**CABINET MEMBER FOR HIGHWAYS MANAGEMENT – 16  
DECEMBER 2021**

**OXFORD: HEADINGTON QUARRY CONTROLLED PARKING ZONE –  
PROPOSED AMENDMENTS TO WAITING RESTRICTIONS**

Report by Corporate Director, Environment and Place

Drawing title  
**ZONE AMENDMENTS  
 PROPOSED NEW DOUBLE YELLOW LINES  
 GLADSTONE ROAD**

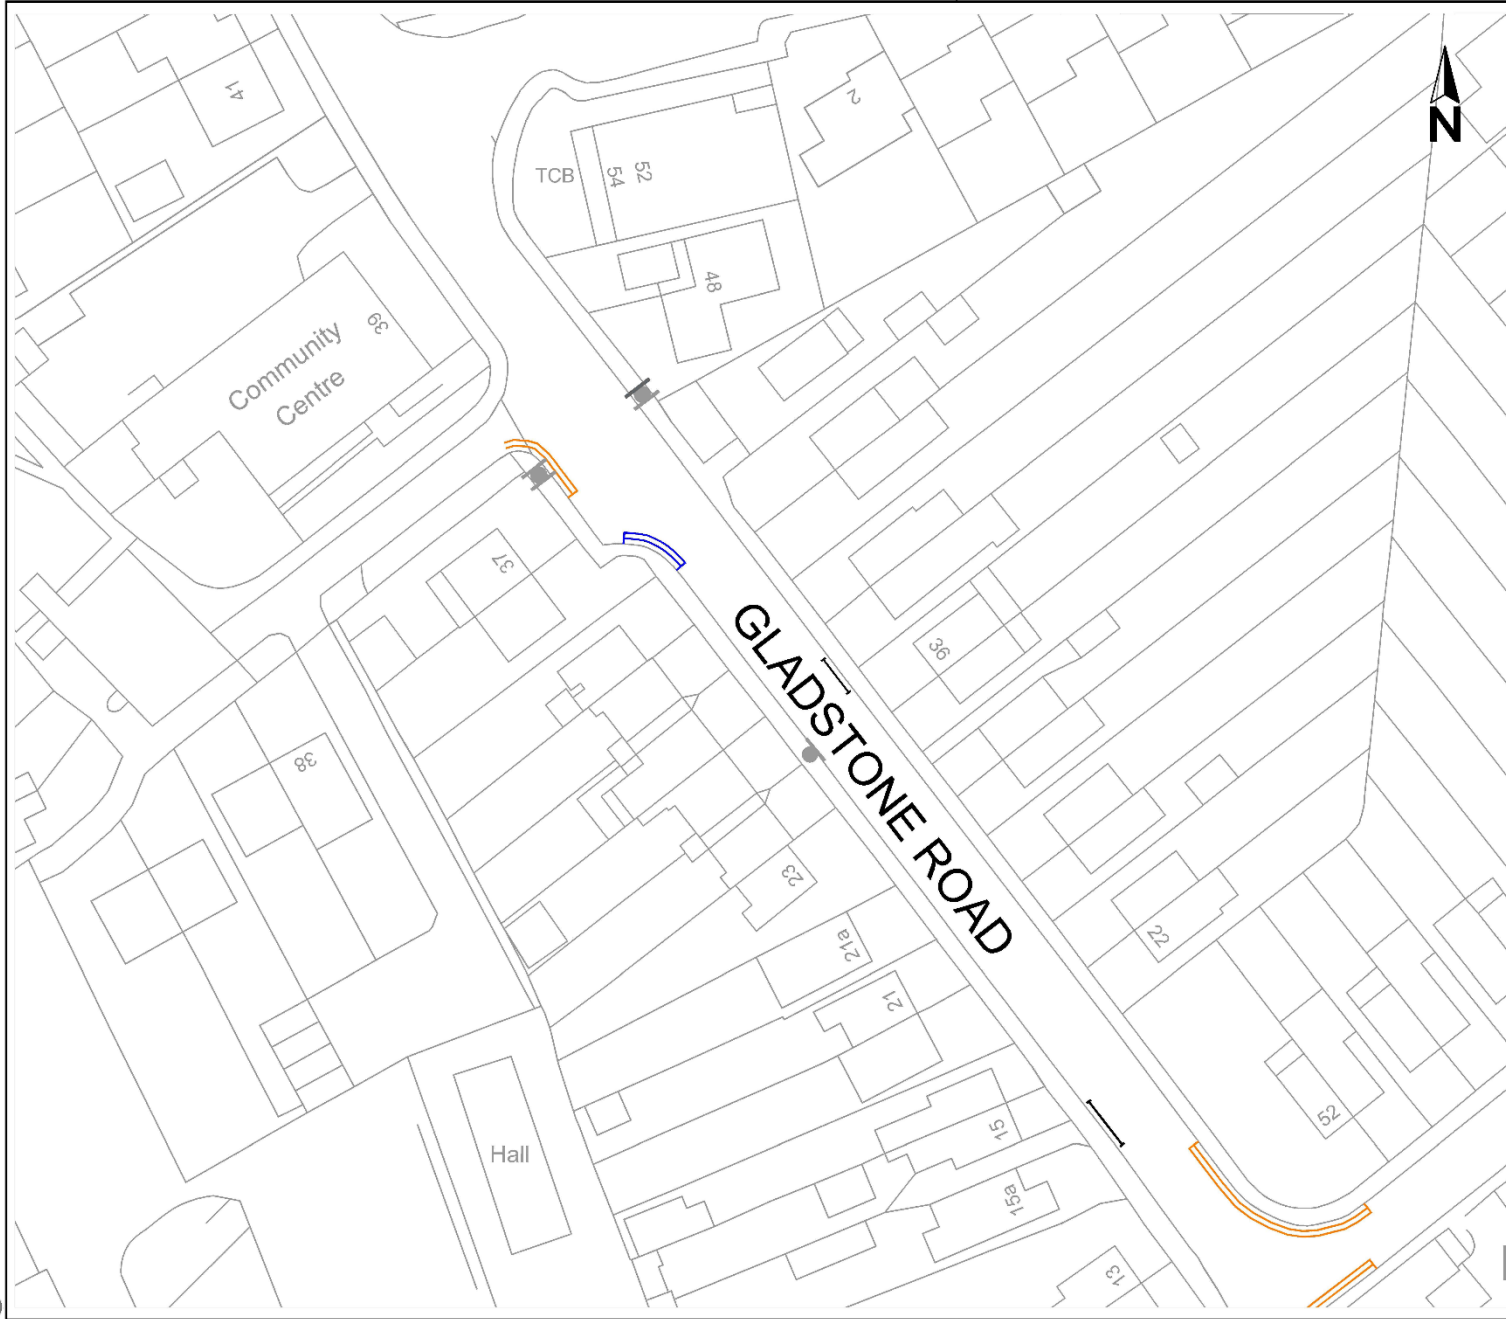
(5) Local Resident, (Headington Quarry, Gladstone Road)	<p>Gladstone Road (DYLs) - <b>Object</b></p> <p>The proposed yellow lines outside 33 Gladstone road would leave just 2 parking spaces by our house. The layby type</p>

<p>area right outside our house is already double yellow lines. This would leave space for just 2 cars opposite. The property at 31 is student accommodation and they often have had to park opposite. In short this leaves 2 spaces left as we live right on the edge of the zone so can't park to the left of our house.</p>
<p>(6) Local Resident, (Oxford, Gladstone Road)</p>	<p>Gladstone Road (DYLs) - <b>Object</b></p> <p>I am writing to register my strong objection. I am also mystified as to the reason why it is being proposed. As our correspondence shows, I have already outlined the reasons for my concern previously to you, and my worries remain the same. I also voiced my concerns at the last meeting at Quarry Hall, and it seemed that everyone was in agreement. There was no-one who was in favour of double yellow lines being there, and I am therefore left wondering why they are being proposed at all? I would be grateful if you could please let me know.</p> <p>The parking space outside my house serves as a vital space for myself as well as my immediate neighbours, who both use the space very often. My neighbours at 37 did not take any role in the first round of proposals at all - indeed they appeared absolutely unaware of them - even though they own more than one car at the property. As a result, they very often use the space where the yellow lines are being proposed as they have no space outside their property. If this space is taken away, it will definitely lead to people (including the residents of 37 Gladstone road) double parking with the disabled parking bay. This is both a hazard to passing traffic and also makes it extremely difficult and impractical for me to get into my car when it is in the disabled parking bay, as people park so closely it obstructs my doors.</p> <p>Also, I would like to emphasize that the disabled parking bay is not only for myself and is also frequently used by other disabled users. This has become more common since Headington Community Centre recently resumed events. It is not uncommon for myself to return home to find another car in the space, and if the yellow lines were put in place outside my house, I would have great difficulty finding somewhere else close by to park.</p> <p>There is also the issue of speeding. This is already a problem, as the space where the lines are proposed is a rare example of a straight portion of road in the Quarry, and drivers often speed up on it. Having a car parked there presently slows traffic, as drivers are forced to slow down to give way or negotiate oncoming traffic. If a car is unable to park there in the future and there is a clear space instead, this will cause drivers to feel comfortable driving even faster than they already do.</p> <p>Access to the driveway of 33 is not obstructed or affected in anyway. Both myself at 35 and next door at 37 do not have the option of creating off-road parking with a drive as other neighbours have done, because of the</p>

<p>impracticalities of the below street-level gardens. Therefore, it is vital that the space for residents parking there remains. As I have said above, I am at a loss to wonder why taking the space away has even been proposed, given my previous objections. I have voiced these both in person at the meeting in the winter of 2020, and also to yourself in writing previously, so I hope you understand that I am surprised at the proposal and am very worried about it. I am quite sure when I say that no-one thinks that the proposed changes will have a positive effect. Cars parked there do not block either the drive of 33 Gladstone road nor the disabled parking bay. Furthermore, I am still unsure how a car parked parallel to the pavement there can have any more of an effect on pedestrians as a car parked anywhere else could. I am very worried that it will just lead to double parking, which was an issue before the CPZ.</p>

(7) Resident, (unknown)	<p>Gladstone Road (DYLs) - <b>Object</b></p> <p>I oppose the parking restrictions due to take place on Gladstone Road. This is because, residents are already paying to park on the road and there is a disabled resident who will be badly affected if this proposed parking restriction comes into effect.</p>

<p>yield to one another efficiently.</p>
<p>(49) Local Resident, (Oxford, Gladstone Road)</p>	<p>Gladstone Road (DYs) - <b>Support</b></p> <p>We are the residents that live on Gladstone Road where the proposed double yellow line would be put in place. We believe this is long overdue proposal stretching back many years. Parking on this small space on a bend has always been a danger especially to the young children from the nursery. When leaving our driveway it is very difficult to see little ones running along the pavement round the bend. With the bushes &amp; parked vehicles there have been some near misses.</p> <p>This is a controlled parking zone with no clearly marked parking bays. If it was this bend would never be a parking bay due to the safety issues mentioned above. We fully support the proposal.</p>

- b) Not approve the proposed additional ‘no waiting at any time’ (double yellow lines) in Gladstone Road outside No. 35
  - c) Approve the proposed additional ‘no waiting at any time’ (double yellow lines) as advertised on the Northern side of Trinity Road outside No. 21
